Previous comment:
Page 3 of the PBMP Applicability Form shows LOD as 1.104ac. Revise to remove discrepancies.

PROJECT
ROCKY TOP MOTEL & CAMPGROUND
PART NW1/4 SECTION 9, T.13S., R.68W., 6TH P.M.
EL PASO COUNTY

SHT. NAME
GRADING AND EROSION CONTROL PLAN

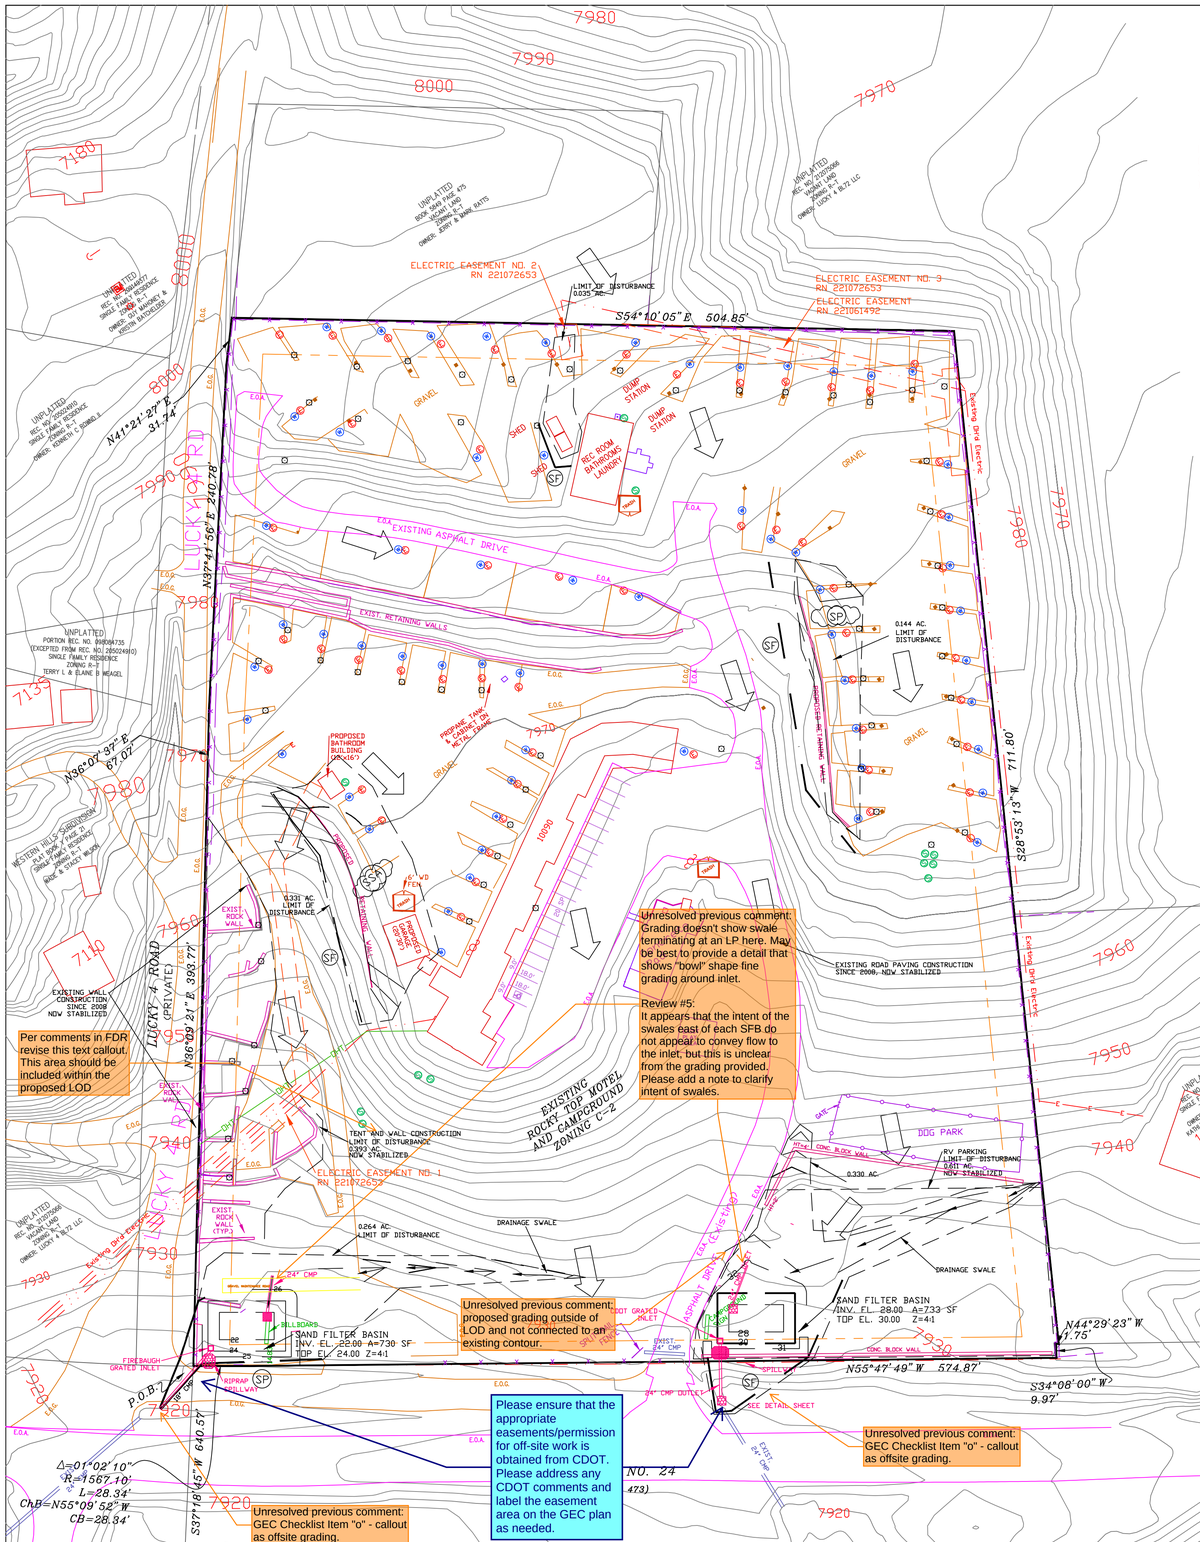
Review #5 comment:
Per latest comments in the FDR, this area should be listed as "1.497ac" (1.104ac + 0.393ac).

This row of text was added per my comment on the last submittal. This is not sufficient. Areas of cut AND areas of fill must be identified SEPARATELY to satisfy GEC Checklist Item "i." To satisfy this requirement, most engineers create a linetype for cut/fill and label one side of the line as "cut" and the other as "fill" throughout the plans.

WEST SFB DETAILS

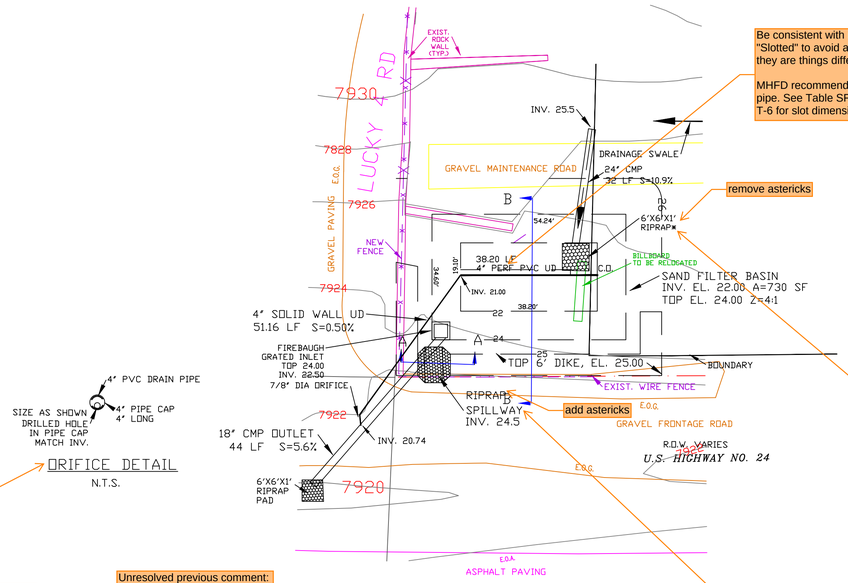
where is this cleanout located on each SFB? Show and lable on each plan detail on this sheet.

Unresolved previous comment:
- Clarify where the transition occurs from solid wall to slotted.
- Also show a section view of how underdrain is to be installed, as seen on pg SF-8 of MHFD Detail T-6

Review #5: the section view should show things like grading of subgrade, depth of underdrain in filter media, etc.

PLAN

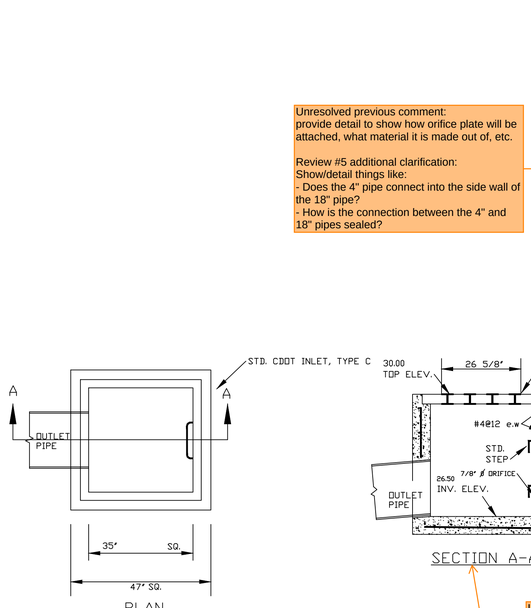
Unresolved previous comment:
provide detail to show how orifice plate will be attached, what material it is made out of, etc.

Review #5 additional clarification:
Show/detail things like:
- Does the 4" pipe connect into the side wall of the 18" pipe?
- How is the connection between the 4" and 18" pipes sealed?

Unresolved previous comment:
provide detail to show how orifice plate will be attached, what material it is made out of, etc.

Review #5 additional clarification:
On the newly added Orifice Detail, also show/detail things like:
- Does the 4" pipe connect into the side wall of the inlet box?

- How is the connection sealed between the pipes and inlet box?
- I would also add a note detailing how you want the orifice plate installed. For example: the underdrain pipe could come through the inlet box far enough to get a cap on it (which will have the orifice on it). Otherwise, the pipe could instead be cut flush with the wall of the inlet box and it will be very difficult to install the cap (since there will be no room to then add a 4" PVC coupling), so the likely solution would then be to bolt a metal orifice plate to the side of the inlet box with a gasket (which will take more time and money). Summary: just clarify what you want to avoid errors in the field. We have previously seen in the field issues with the installation of th orifice plate because of lack of details on the drawings.
Be clear that each SFB's orifice details are unique.

SECTION A-A

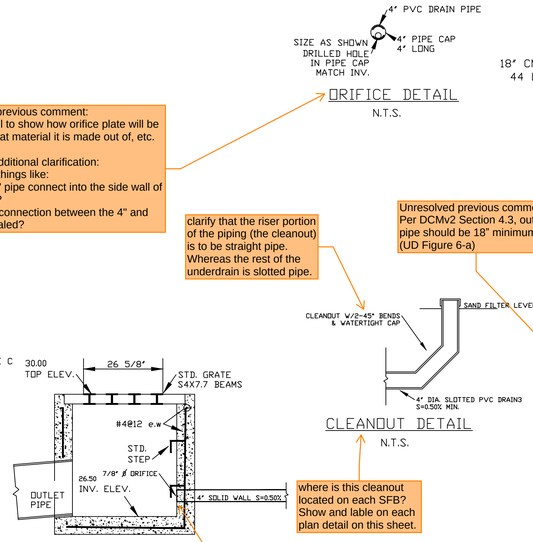
Revise to "CDOT Inlet Detail" or similar. Section A-A is for the spillway

SECTION B-B

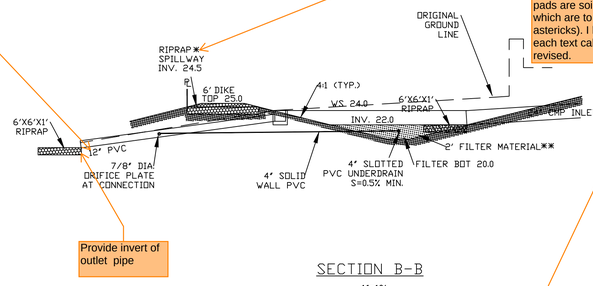
Unresolved previous comment:
This type of soil riprap with topsoil is fine for the spillway but is not appropriate for the erosion protection at the bottom of the SFB where the inlet pipe outfalls. We don't want to encourage the growth of vegetation with the topsoil nor do we want to introduce more sediment into the SFB which will cause extra maintenance.

So create a separate asterisk or text callout for these locations.

Additional clarification for this submittal:
Or clarify with revising text callouts as to which pads are soil riprap (via astericks on each) and which are to be just riprap (ie: no soil, so no astericks). I have added individual notes to each text callout that I think needs to be revised.
